UNITED STATES PATENT AND TRADEMARK OFFICE

APPLICATION NO.	FILING DATE	FIRST NAMED INVENTOR	ATTORNEY DOCKET NO.	CONFIRMATION NO.
10/790,432	03/01/2004	Rick James Morse	D0932-00431	9791
8933	7590	03/22/2007		
DUANE MORRIS, LLP IP DEPARTMENT 30 SOUTH 17TH STREET PHILADELPHIA, PA 19103-4196			EXAMINER KENNY, DANIEL J	
			ART UNIT	PAPER NUMBER
			3635

Office Action Summary

Annotated Fig. 1 (U.S. Pat. 5,916,095)

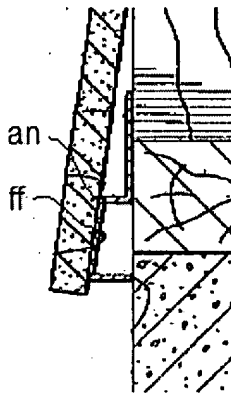
Claims 1, 2, 4, and 5 are rejected under 35 U.S.C. 102(b) as being anticipated by Tamlyn (5,916,095).

Tamlyn discloses a (note: The product by process limitation, extruded, does not structurally define over the reference as applied to the claims because the reference article is made of plastic) plastic (col. 4, line 12) starter strip (20) comprising:

a fastener flange (28);

a siding support element (32) connected (connected via 30) to the flange,

wherein the support element has a front face (ff);

a spacer element (30) connected to the siding support element, wherein the spacer includes an angle component (an) wherein the front face and the angle component are inclined at an equal 3° angle ($\tan^{-1} \frac{1}{2} \approx 3^\circ$, col. 4, lines 39-45) away from vertical; and

a flashing element (34) connected to the spacer element.

Annotated Fig. 3 (U.S. Pat. 4,034,012)

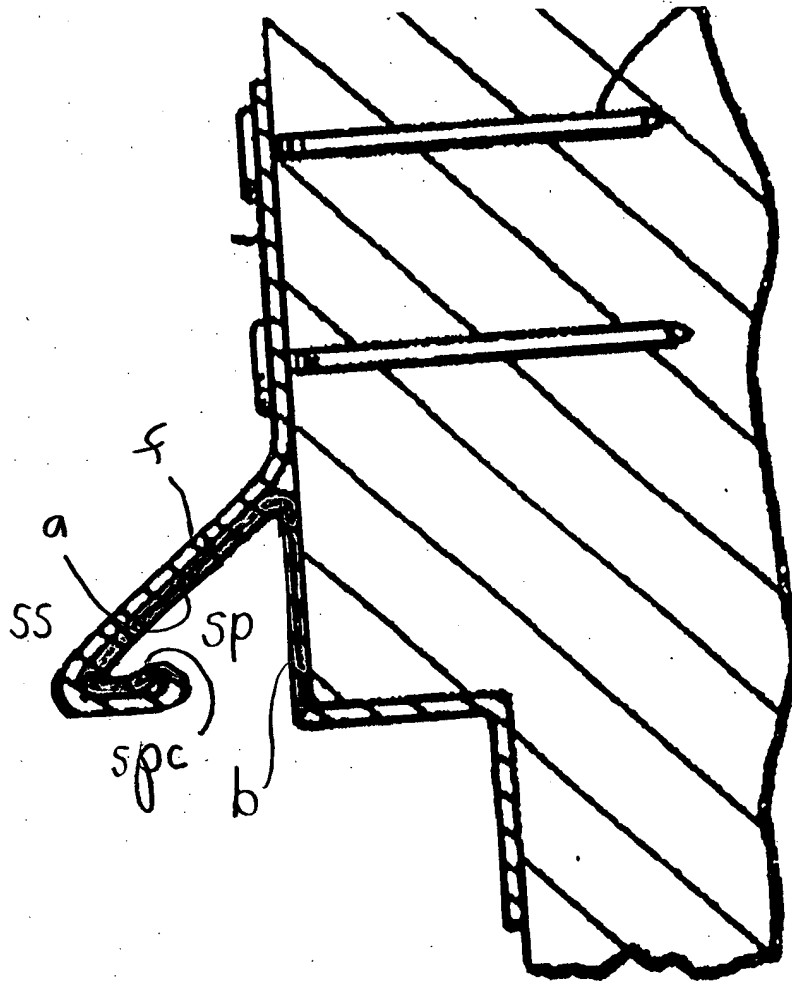
Claims 1, 3, and 6 are rejected under 35 U.S.C. 102(b) as being anticipated by Paradisi et al.

Paradisi discloses a folded metal (col. 2, line 35) starter strip (14) comprising:

a fastener flange (18);

a siding support element (ssup, see annotated Fig. 3 below) connected to the flange, wherein the support element further includes a first (fh) and second (sh) horizontal member which are substantially perpendicular to the fastener flange;

a spacer element (spa) connected to the siding support element; and

a flashing element (20) connected to the spacer element.

Annotated Fig. 3 (U.S. Pat. 4,054,012)

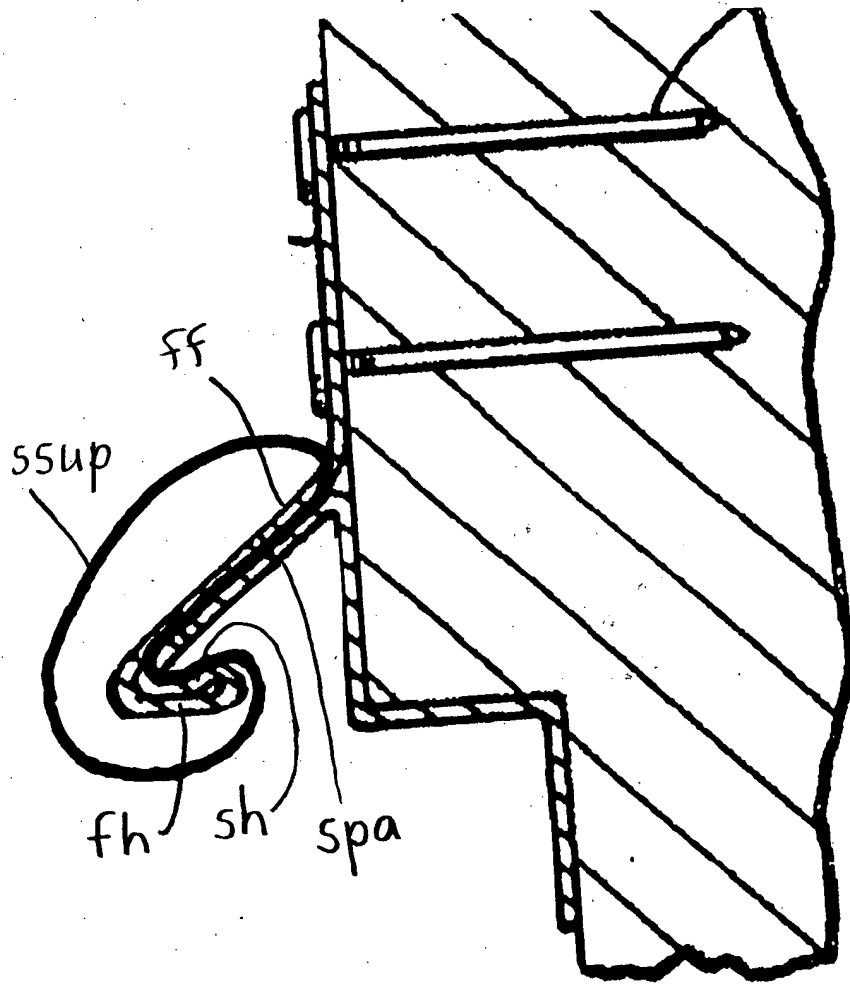
Claims 1, 3, 4, and 10-12 are rejected under 35 U.S.C. 102(b) as being anticipated by Paradisi et al. (4,054,012).

Paradisi discloses a folded metal (col. 2, line 35) starter strip (14) comprising:

a fastener flange (18);

a siding support element (ss) connected to the flange, wherein the support element has a front face (f);

a spacer element (sp, see darkened portion shown at annotated Fig. 3 directly below) connected to the siding support element, wherein the spacer includes an angle component (a) wherein the front face and the angle component are inclined at an equal angle away from vertical; and

a flashing element (38, 40) connected to the spacer element, wherein the flashing element includes a horizontal (38) member wherein an end extends beyond the plane of fastening flange and an end terminates at a point even with the plane of the fastening flange, and a vertical (40) member.
